Re: Pio Pico Energy Center Project (11-AFC-01)
Application for Certification Refinement - Enhanced Water Treatment System

APPLICATION FOR CERTIFICATION
FOR THE *PIO PICO ENERGY CENTER, LLC*

Docket No. 11-AFC-1
PROOF OF SERVICE
(Revised 5/15111)

**FIGURE 3.1-3A (REVISED)
SITE ARRANGEMENT**

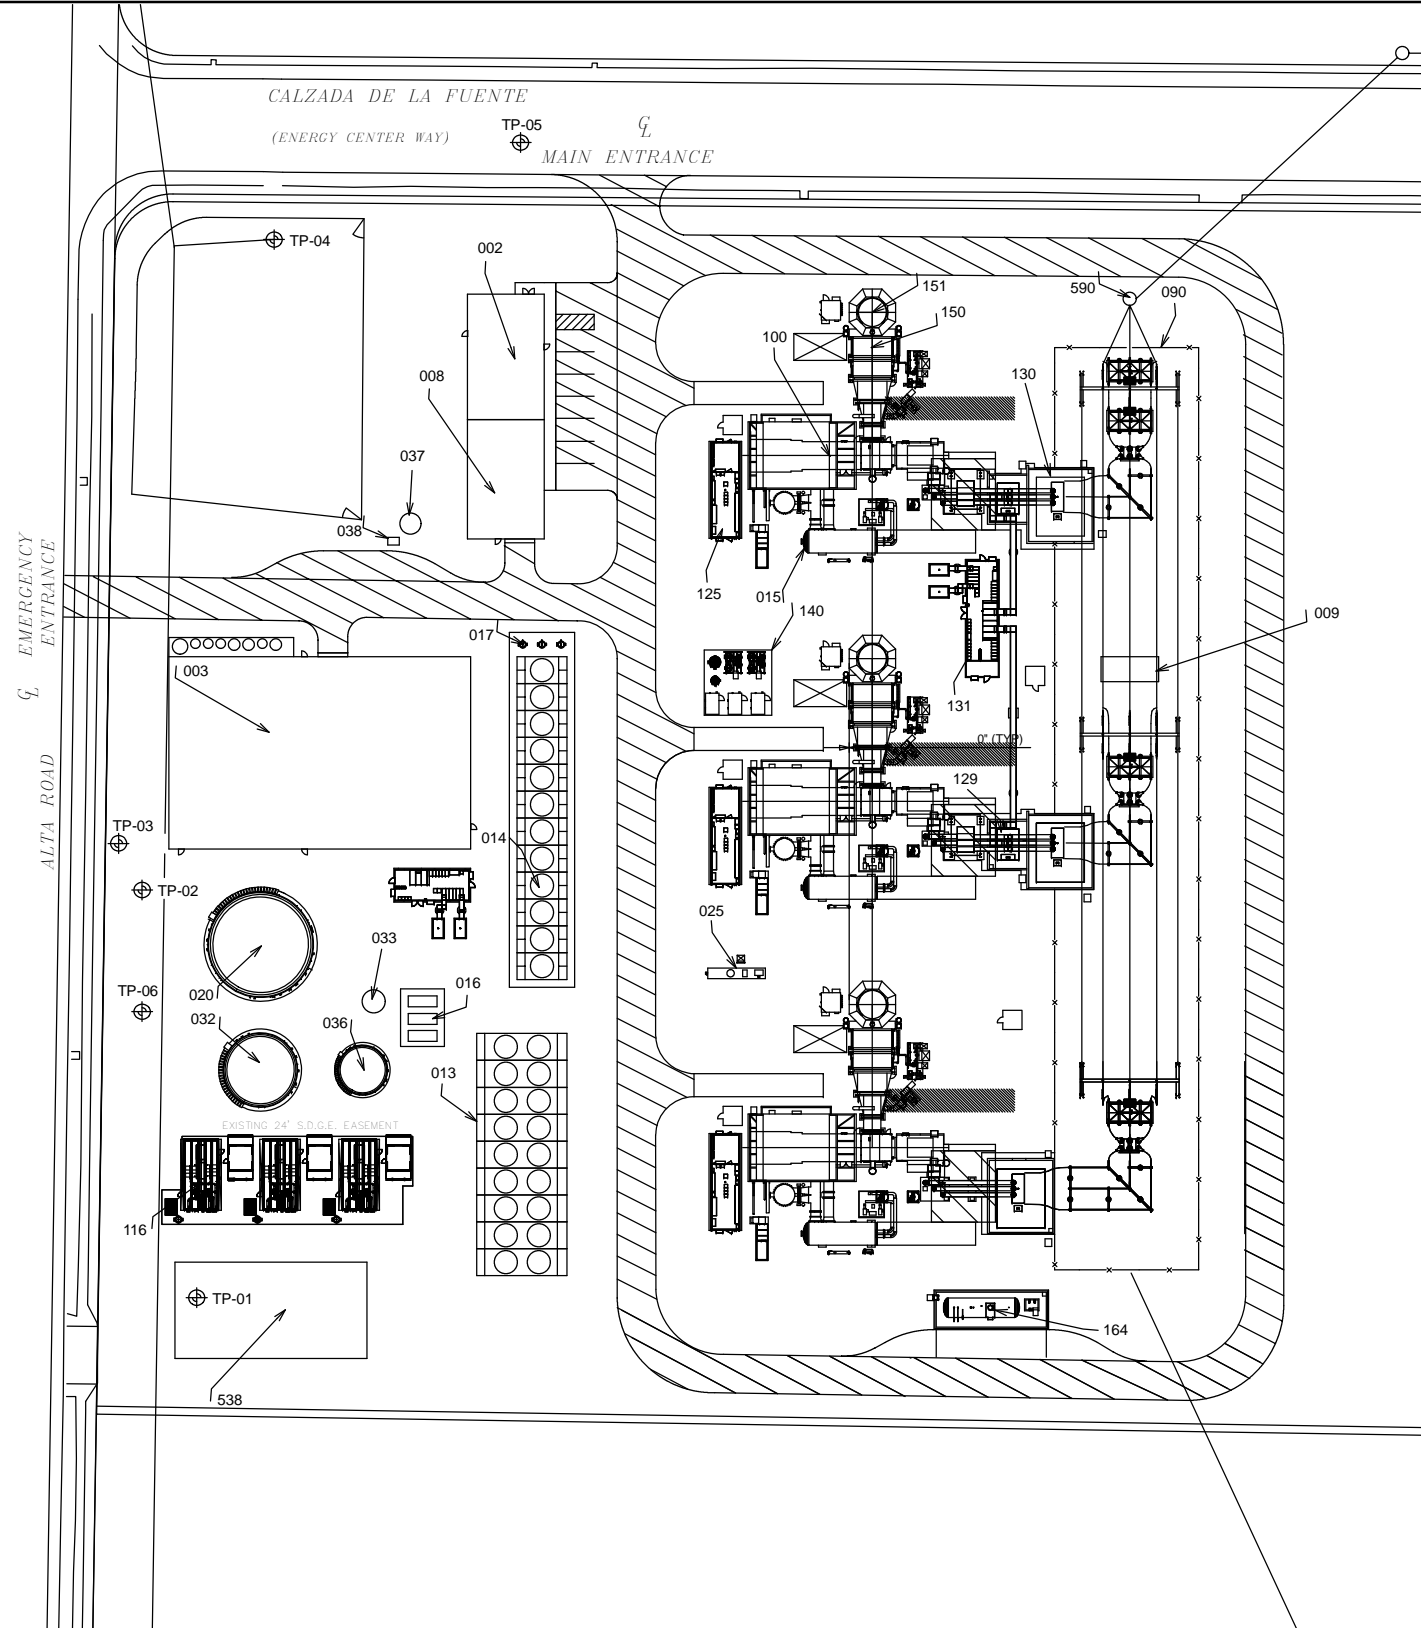
The EWT System consists of an enlarged water treatment building containing the high-pH RO wastewater treatment system, additional piping, proposed FWST and proposed transport tanker staging area, as shown on Revised Figure 3.1-3A, Site Arrangement. Addition of the EWT System does not result in any changes to the power block area layout or the majority of balance of plant equipment.

The water treatment building will be expanded by approximately 9,200 square feet to house the EWT System equipment as shown on Revised Figure 3.1-3A, Site Arrangement. The original proposed water treatment building was 6,300 square feet and the revised building will now be 15,500 total square feet. The type of foundation will be the same, either mat foundation or

The EWT System will have a wastewater truck loading area, as shown on Revised Figure 3.1-3A, Site Arrangement. This area will be located south of the stormwater detention basin. BMPs would be implemented to prevent the discharge of final process wastewater into the stormwater detention basin. These could include:

The EWT System would expand the previously proposed water treatment building and add a Final Wastewater Storage Tank (FWST), the design details and aesthetic impacts of which are described below. These changes are also shown on Revised Figure 3.1-3A, Site Arrangement.

**FIGURE 3.4-3 (REVISED)
PRELIMINARY GRADING
AND DRAINAGE PLAN**

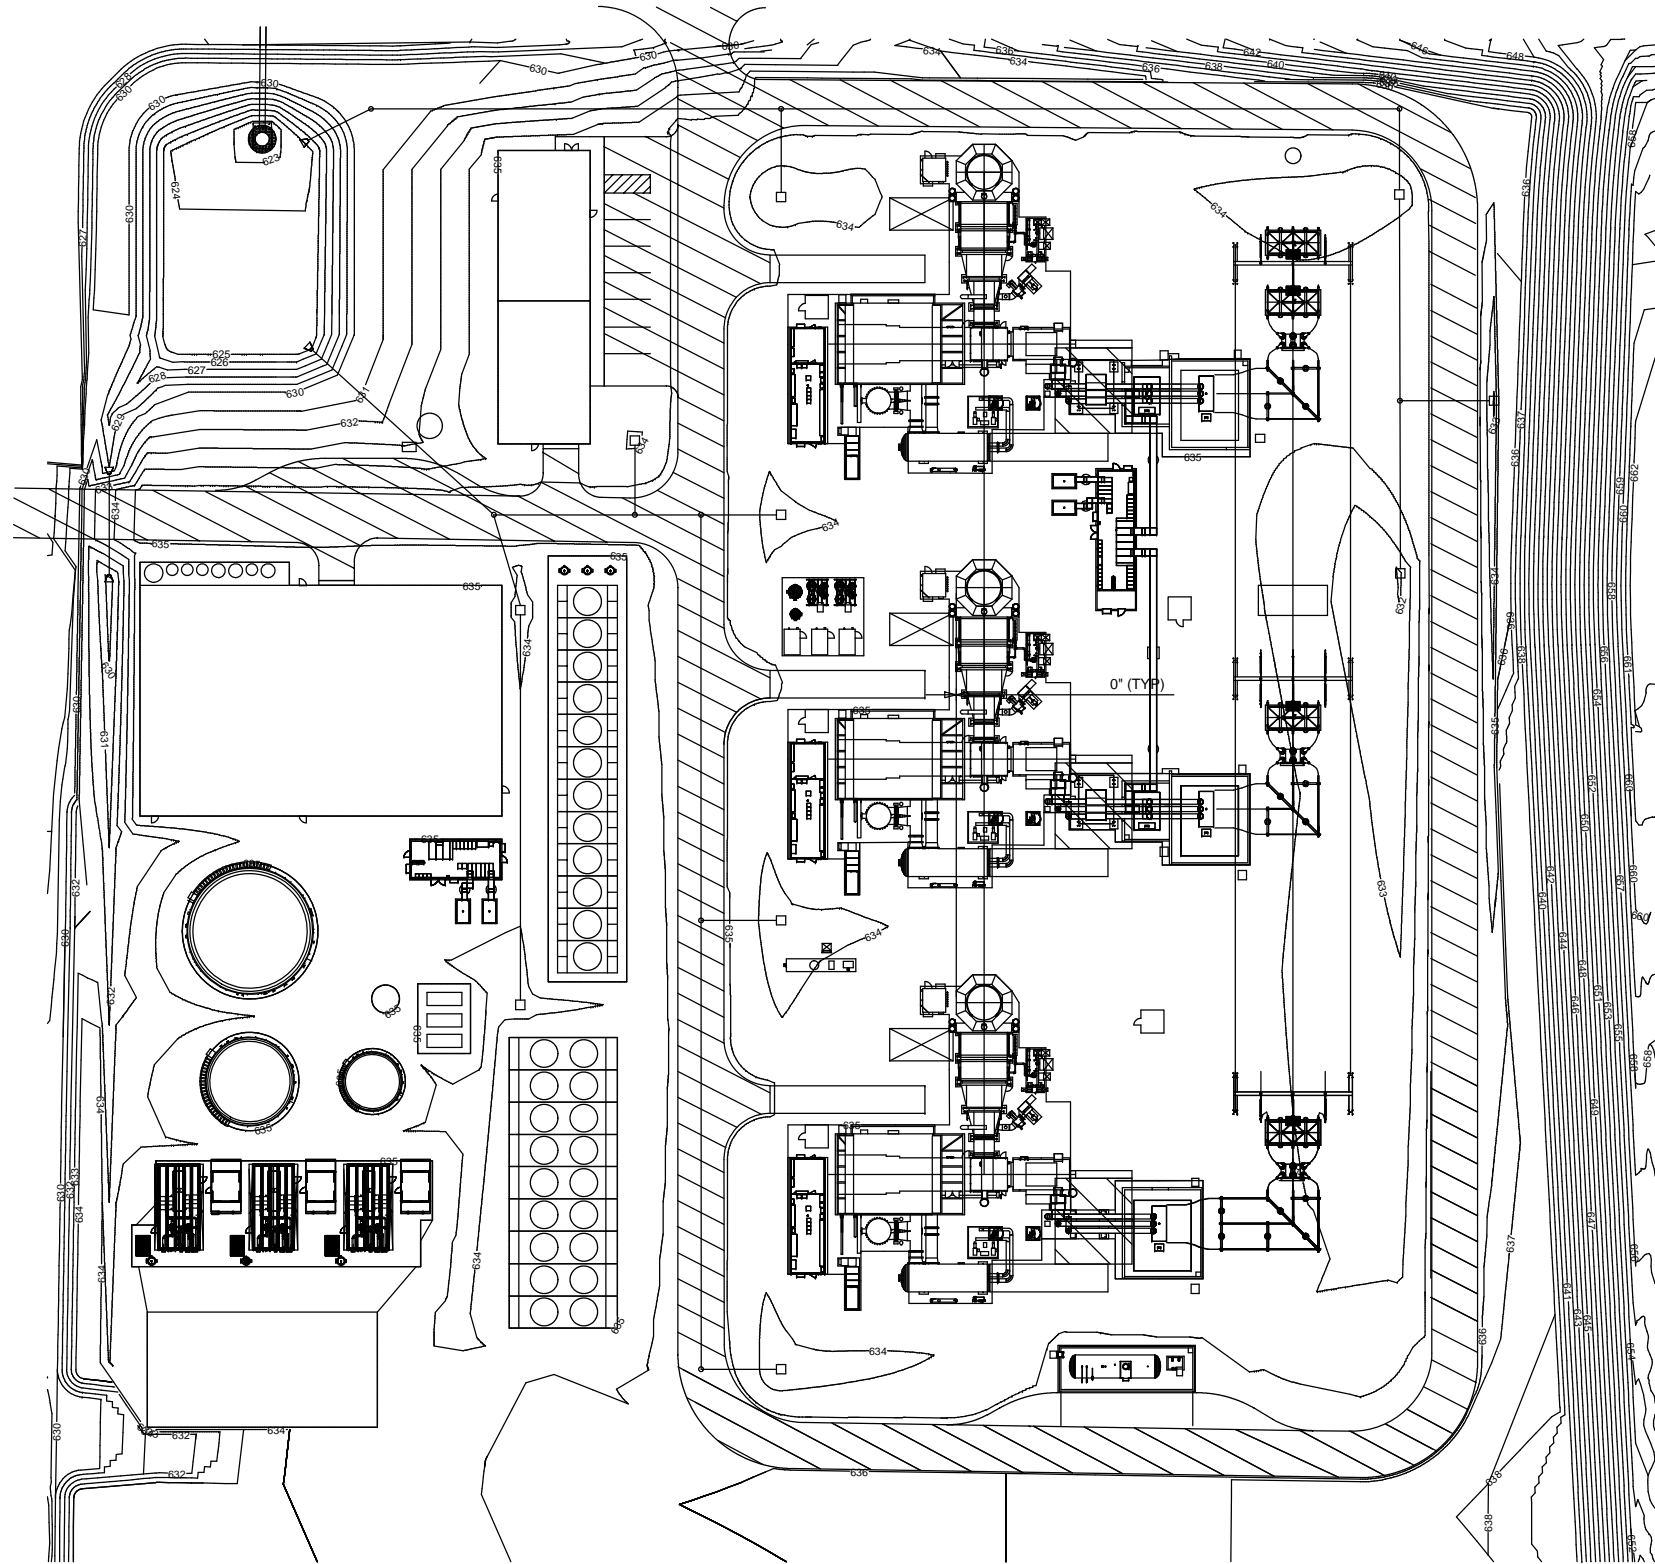
Revised Figure 3.4-3, Preliminary Grading and Drainage Plan, shows the changes to the site to accommodate the expanded building. The modifications associated with the EWT would not substantially change stormwater management at the site. See discussion in Section 5.5, Water Resources, in this AFC Refinement for additional information.

The site grading and drainage plan for PPEC is shown on Revised Figure 3.4-3, Preliminary Grading and Drainage Plan of this AFC Refinement. As a result of the enlarged water treatment building associated with the EWT System, the project will increase the amount of impervious surface area slightly (i.e., by approximately 0.2 acre), such that the total amount of impervious surface area would still be approximately 29 percent of the 9.99-acre site. Therefore, there are no substantial changes to the preliminary drainage calculations or sizing of the onsite detention basin as provided in the February 2011 AFC.

S	Detailed WWT	BMC			
Rev	DESCRIPTION	Dwn	Chk	App	Date
	PIO PICO ENERGY CENTER				
	SAN DIEGO COUNTY, CA				
	3 X LMS100 SIMPLE CYCLE				
9401 Ronner Blvd Lenoxa, Kansas 66219					
WATER BALANCE FLOW DIAGRAM					
Drawn by date			DRAWING NUMBER		
Checked			REVISED		
Approved			FIGURE 3.5-4A

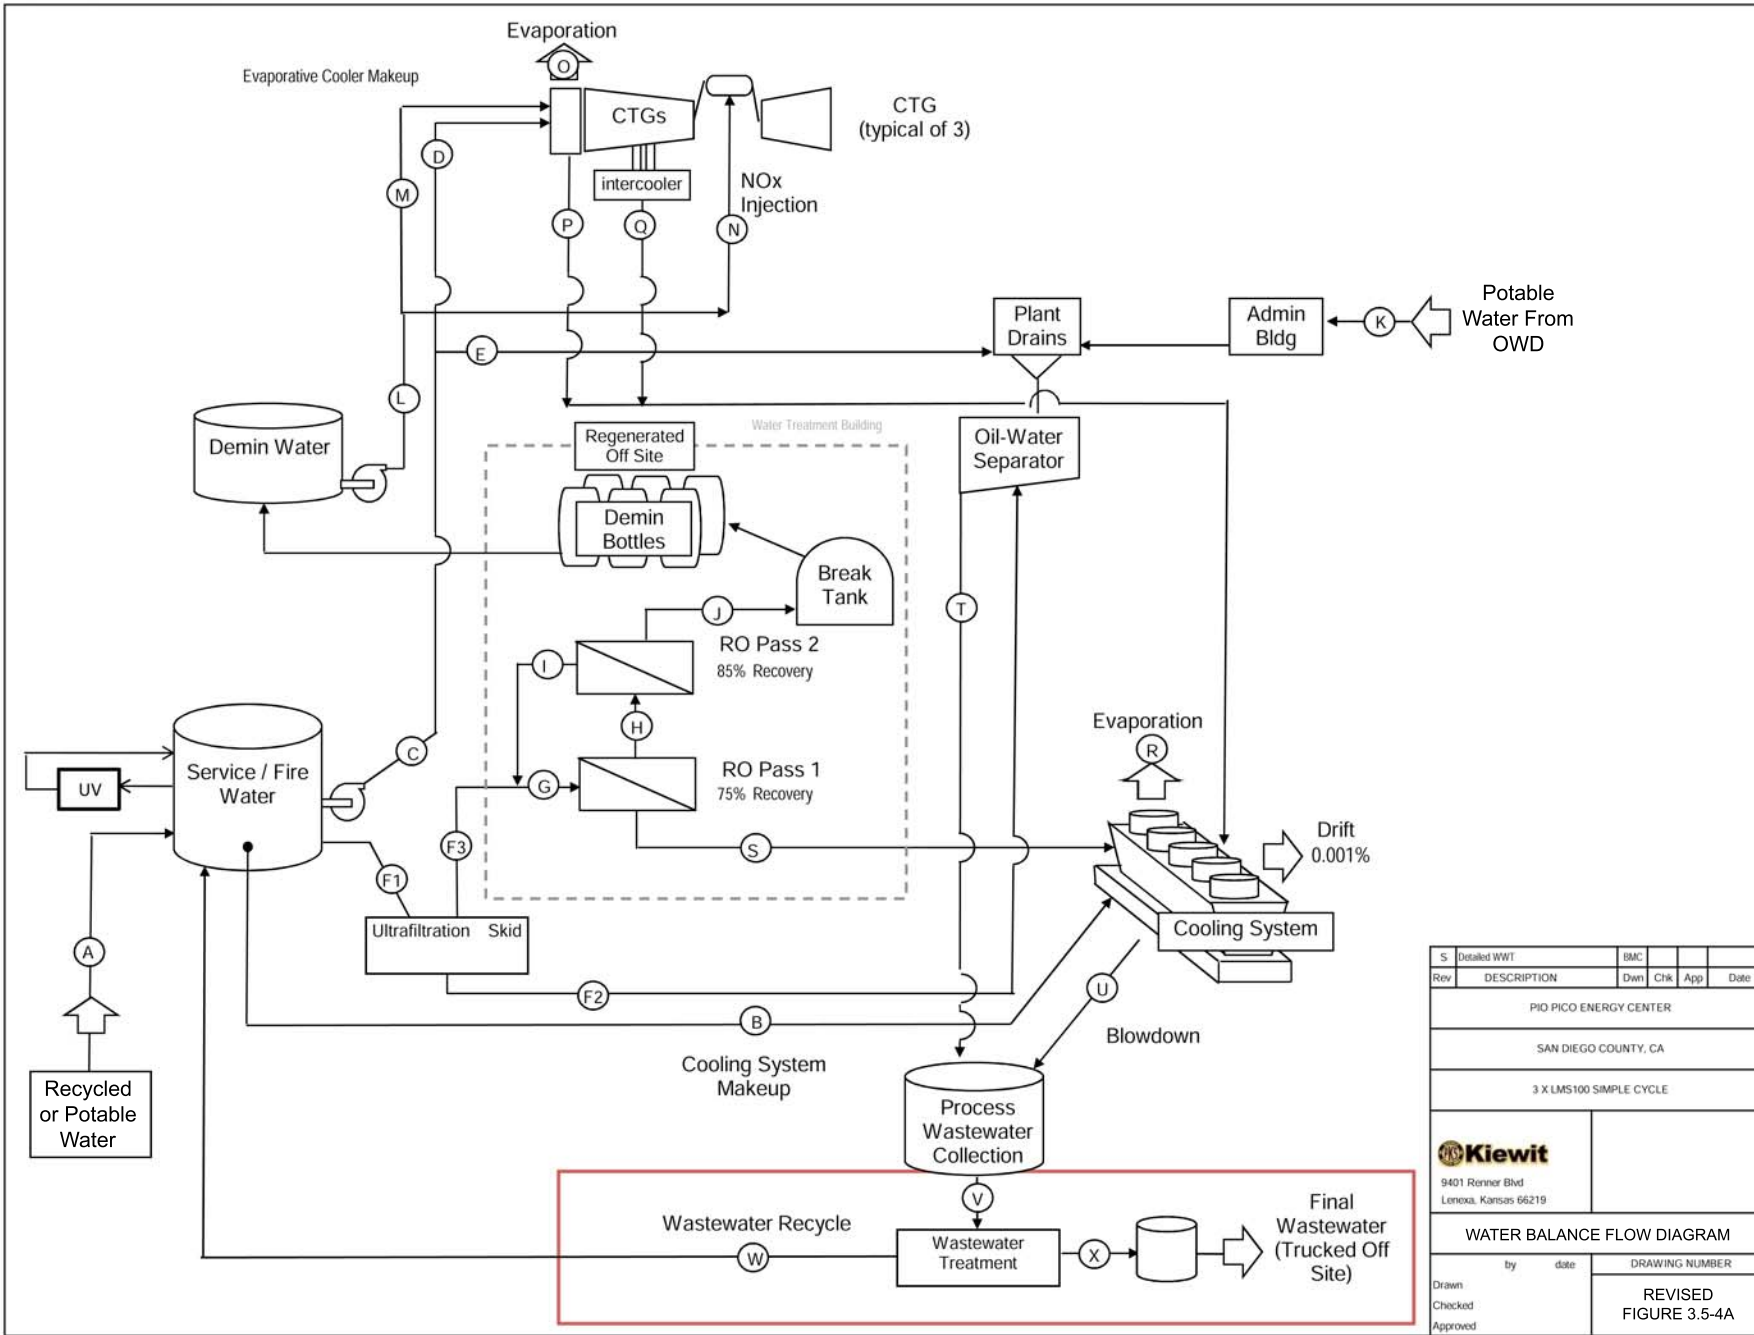
The high quality EWT product stream is of better quality than the incoming OWD supplied water and will contribute approximately 17 percent of the required makeup water required by PPEC. See Revised Table 3.5-5 for the expected water quality of the EWT recycled water stream and Revised Figure 3.5-4A for the revised water balance flow diagram.

The EWT System includes additional processing equipment to the wastewater stream described in the February 2011 AFC Section 3.5.7.4, Wastewater Treatment and Discharge. The EWT process is highlighted in a red revision box on Revised Figure 3.5-4A, Water Balance Flow Diagram. The water treatment processes for cooling system makeup water and demineralized water, as described in AFC Section 3.5.7.3, Water Treatment, which are upstream of the EWT System equipment and structures, remain unchanged. The revised water balances correspond to the heat and mass balance diagrams summarized in the February 2011 AFC Table 3.5-2 and shown on Figures 3.5-2A through 3.5-2D, which remain unchanged.
